Interactive comment on “The arctic seasonal cycle of total column CO₂ and CH₄ from ground-based solar and lunar FTIR absorption spectrometry” by Matthias Buschmann et al.

Matthias Buschmann et al.

Received and published: 5 May 2017

Fig. 1. The SNR improvement of a Bruker 125 HR as a function of resolution for a integration time of 5 minutes.

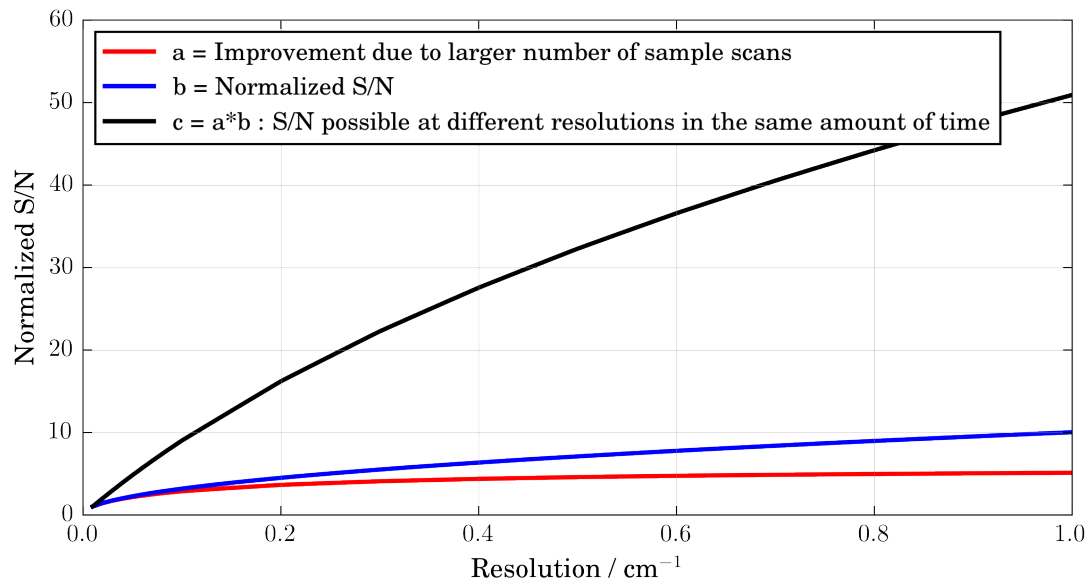
Page 7, line 10 ff: ". . .one option to decrease measurement time . . . is to increase the velocity . . .". No, this is not the case in the context of optimizing the spectral signal-to-noise-ratio (SNR). Here, only the spectral resolution and the throughput matter. I would have expected (for a given allowed integration time) to see a more pronounced reduction of error bars on the retrieved columns until a further reduction of resolution

starts to decrease the contrast between the lines and the adjacent continuum. Has the spectral SNR been adjusted as function of resolution in this manner (assumption of a certain amount of available integration time)? When comparing different resolutions, one might also take into account that a larger fieldstop can be applied when resolution is reduced (increasing the signal level, favoring shorter scans even more).

While the increase in velocity does increase the number of scans possible in the same time frame, this has no effect on the spectral S/N. The wording will be adjusted to clarify. Assuming the second comment refers to Figure 6, no, the data set has not been adjusted for the possible number of spectra within a certain time frame. The aim was to understand what impact the spectral noise has as a function of resolution on the retrieval. A figure highlighting the increase in signal-to-noise ratio (SNR) is included below in Figure 1 and will be integrated in the revised manuscript together with the following explanation: Here the increase in SNR was measured as a function of spectral resolution with a Bruker 125 HR, normalized to the SNR at 0.02 cm^{-1} , i.e. a spectrum recorded with 1.0 cm^{-1} resolution has a 10 times larger SNR (see blue line). Additionally, the shorter scan length allows to record more spectra in the same time frame. Averaging leads to an increase in SNR by a \sqrt{N} with N measurements (red line). The resulting black line shows the potential increase in SNR with resolution for a fixed integration time. At lower resolutions the size of the entrance aperture is limited by the size of the image of the lunar disk, rather than the resolution.

Figure and discussion will be added to Section 3.4 of the final manuscript.
